ZONING BOARD OF APPEALS

1. Minutes of Previous Meeting(s)
2. Consider a Request by Senegy Builders, LLC for a Variance to Reduce the Required First Floor Height from 15 feet to 12 feet 4 inches Located at 130 North 4th Street.

Grand Junction Planning Commission

Consider a Request by Senegy Builders, LLC for a Variance to Reduce the Required First Floor Height from 15 feet to 12 feet 4 inches Located at 130 North 4th Street.

1 WEST EXTERIOR ELEVATION
A201

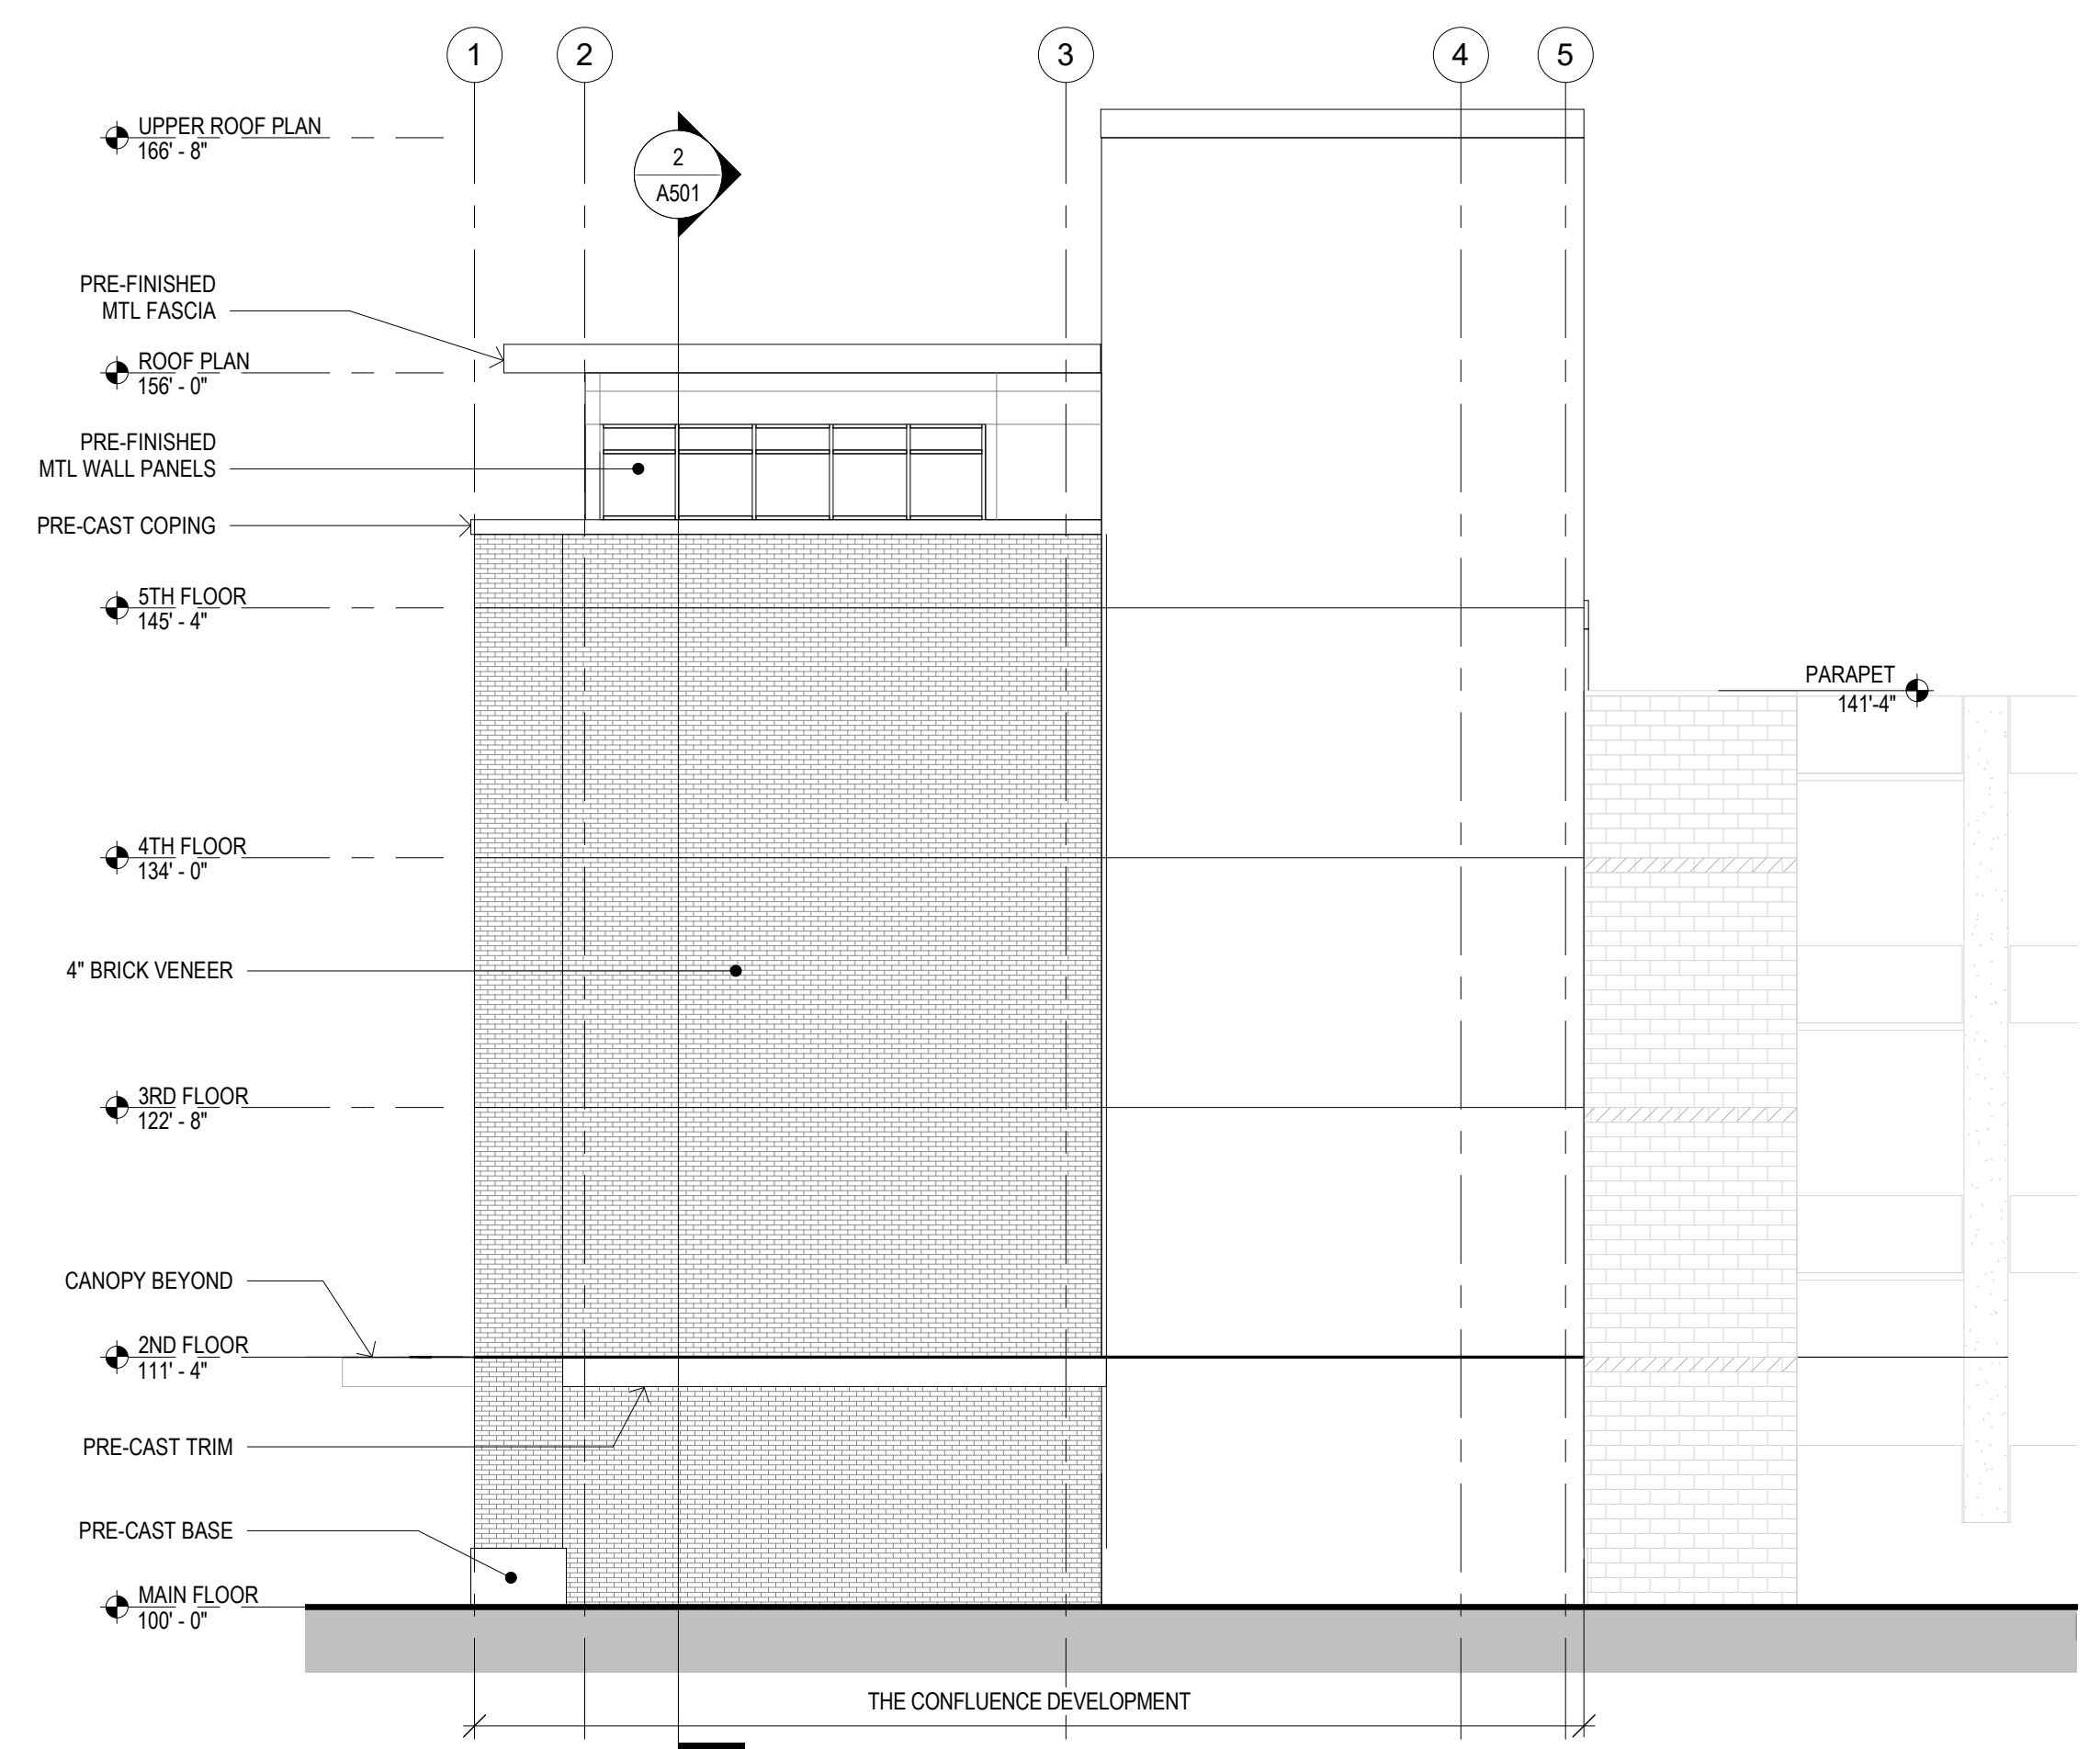
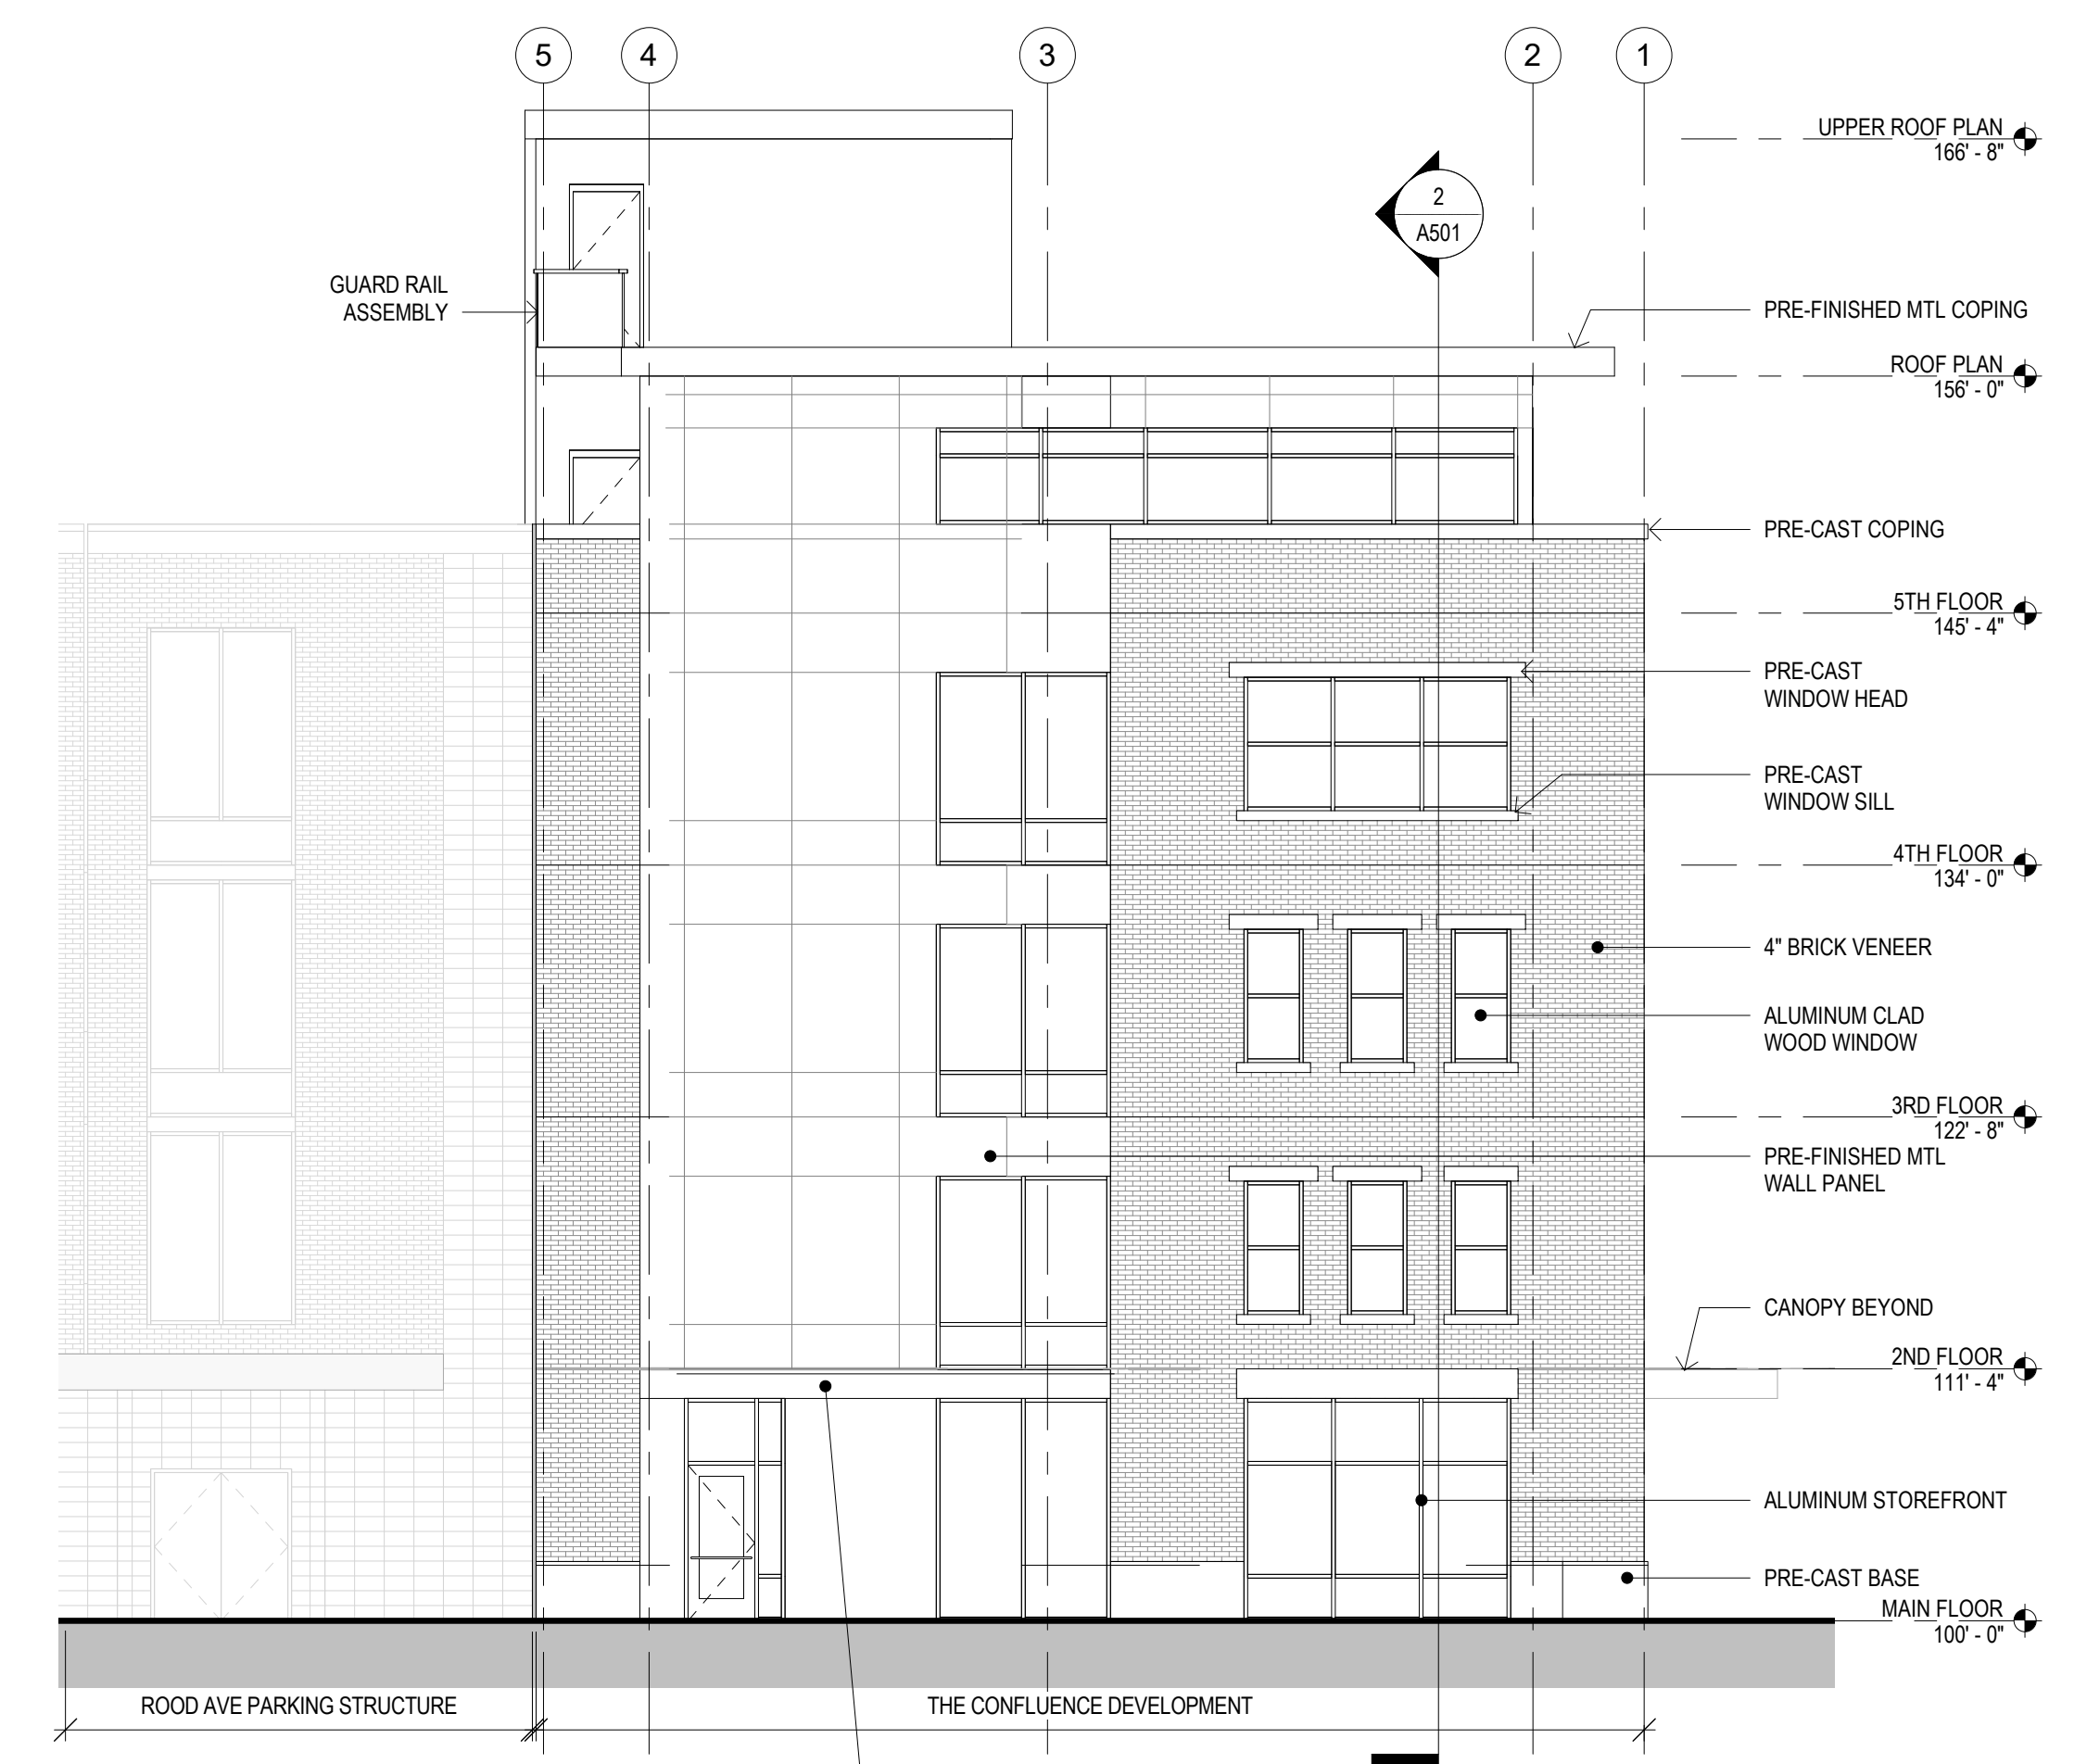
Furthermore, the difference visually may not be perceptible to the public or to users of the building when completed, especially in consideration of the awning that are proposed that will be installed at 14 feet 4 inches. In addition, the bulk standard of the minimum floor height was established in part in the event a new building was constructed downtown directly adjacent to a historic building. so the horizontal alignment was consistent along a street face. The first floor height in many of the historic buildings downtown have a relatively high first floor height so the 15-foot requirement for a new building would result in a horizontal alignment of building façade elements consistent with adjacent buildings. In this case, the proposed building is not directly adjacent to a historic structure so the need to be consistent with proportions on historic buildings is not relevant.

The architect has brought the glass line up to the ceiling height and then pushed up each of the steel canopy's an additional 2 feet in order to give the appearance of compliance while achieving the desired architectural standard. See architectural drawing sheet A201. It was the intent of the City and the DDA to build building on each of the RAPP Endcaps and connect the two structures to the parking garage and; to share the use of the two elevators. A 15 foot first floor height makes this unworkable.
